UNITED STATES NUCLEAR REGULATORY COMMISSION

PHILADELPHIA ELECTRIC COMPANY

Docket No. 50-278

APPLICATION FOR AMENDMENT
OF
FACILITY OPERATING LICENSE
DPR-56

Figure 3.4.1

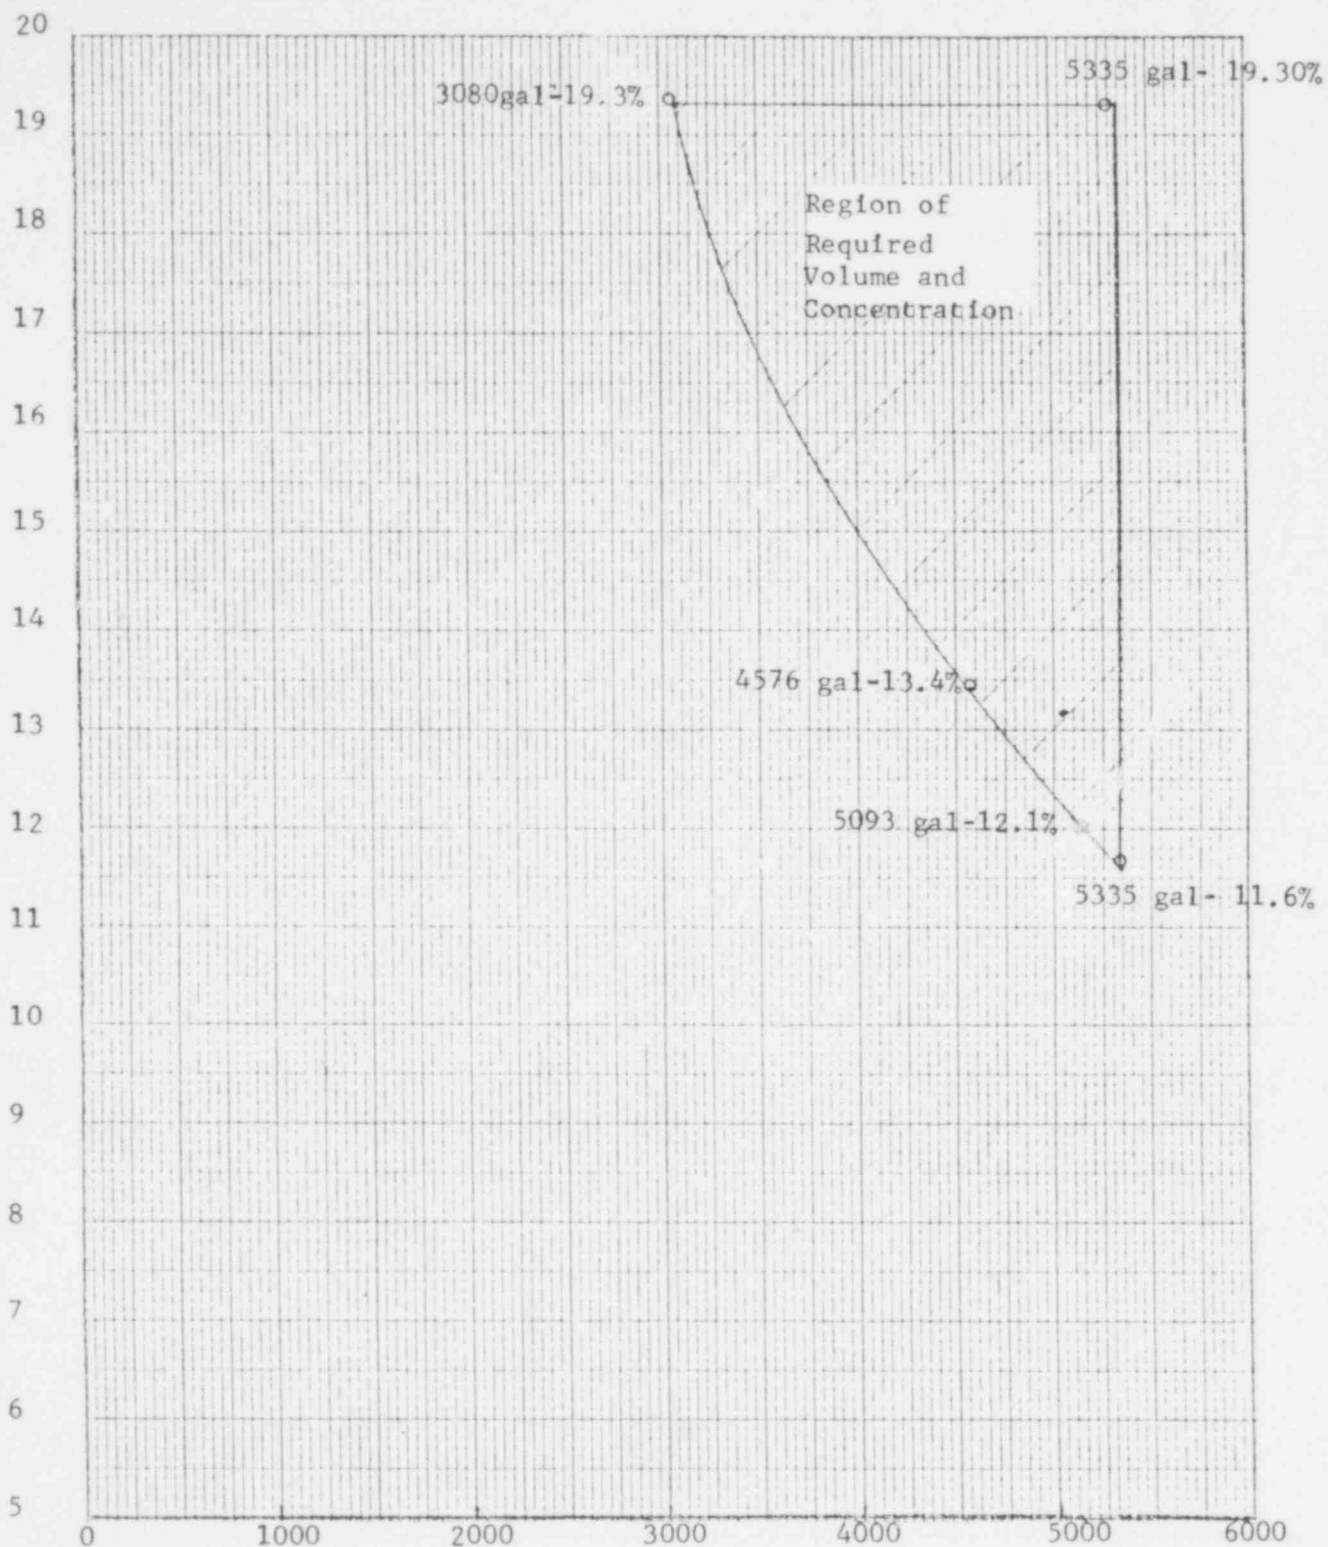
The Technical Specification bases 3.4.A state that the Standby Liquid Control System (SLCS) has the capability of bringing the reactor 3.0% Δk subcritical. The reload licensing analysis for Peach Bottom 3 Reload 3 indicated that the SLCS with its present capability (600 ppm boron) would only bring the reactor 2.2% Δk subcritical. Therefore, the Licensee proposes increasing the SLCS capability from 600 ppm to 660 ppm boron. At this increased boron concentration, the safety analysis provided in NEDO-24204A demonstrates that the SLCS will bring the core to at least 3.2% Δk subcritical.

A minimum quantity of 3080 gallons of solution having a 19.3 percent sodium pentaborate concentration, or the equivalent as shown in Figure 3.4.1, is required to meet this shutdown requirement. The minimum required pumping rate of 43 gpm is based on the injection of the maximum volume permitted in Figure 3.4.1 in less than 125 minutes.

Figure 3.5.1.H Maximum Average Planar Linear Heat Generation Rate
Versus Planar Average Exposure

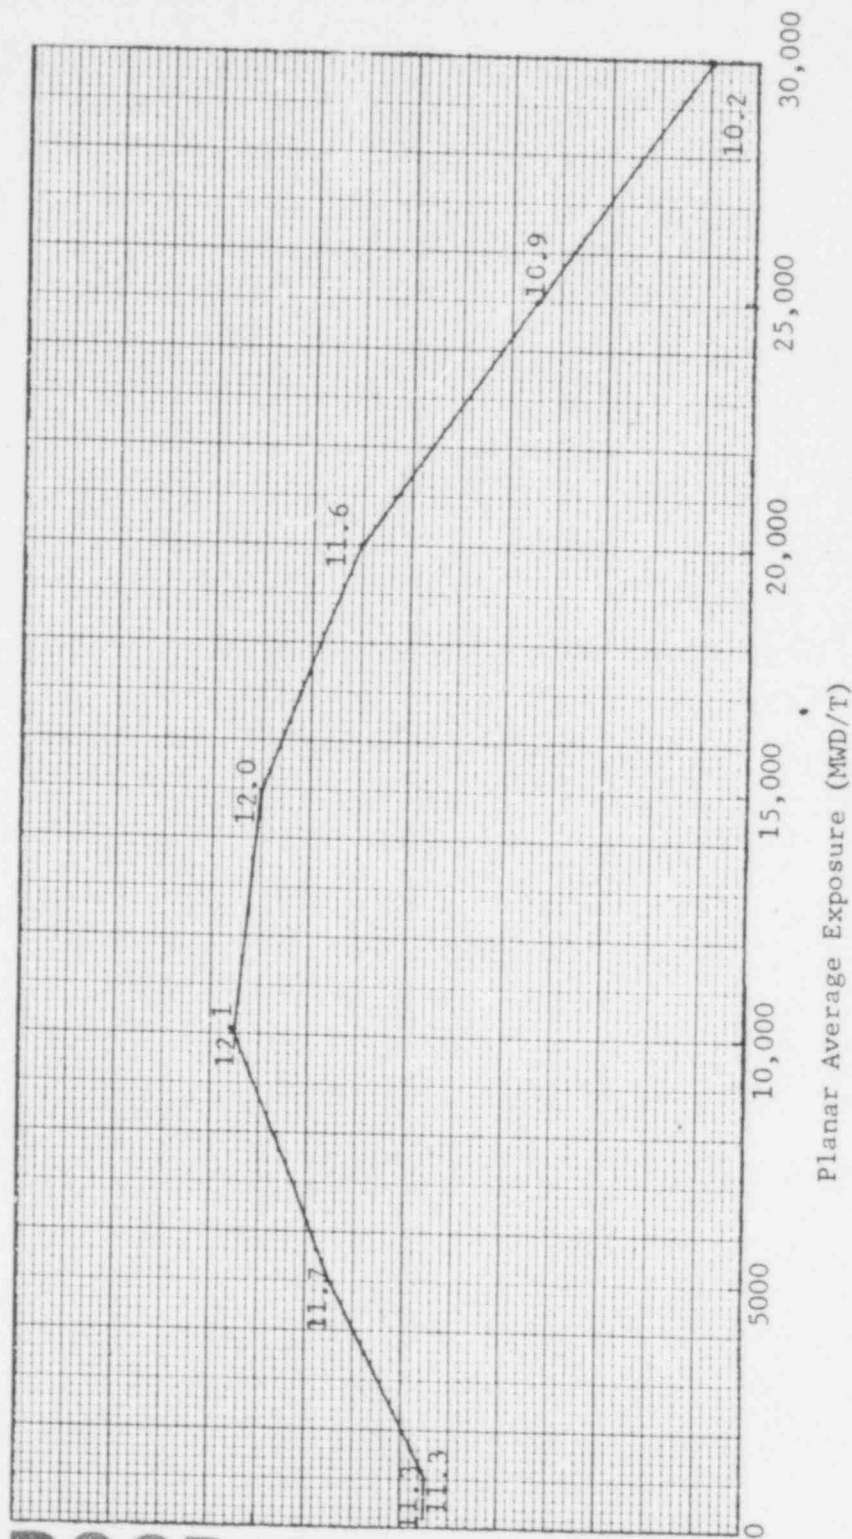
The proposed amendment would permit the loading of the prepressurized retrofit 8X8 fuel design. A safety evaluation for use of the prepressurized retrofit 8X8 fuel, previously approved by the Nuclear Regulatory Commission is provided by General Electric document NEDE-24011-P-A, August, 1978

During power operation, the APLHGR for each type of fuel as a function of average planar exposure shall not exceed the limiting value shown in Figure 3.5.1.A, B, C, D, F, G & H as applicable. If at any time during operation it is determined by normal surveillance that the limiting value of APLHGR is being exceeded, action shall be initiated within one (1) hour to restore APLHGR to within prescribed limits. If the APLHGR is not returned to within prescribed limits within five (5) hours reactor power shall be decreased at a rate which would bring the reactor to the cold shutdown condition within 36 hours unless APLHGR is returned to within limits during this period. Surveillance and corresponding action shall continue until reactor operation is within the prescribed limits.
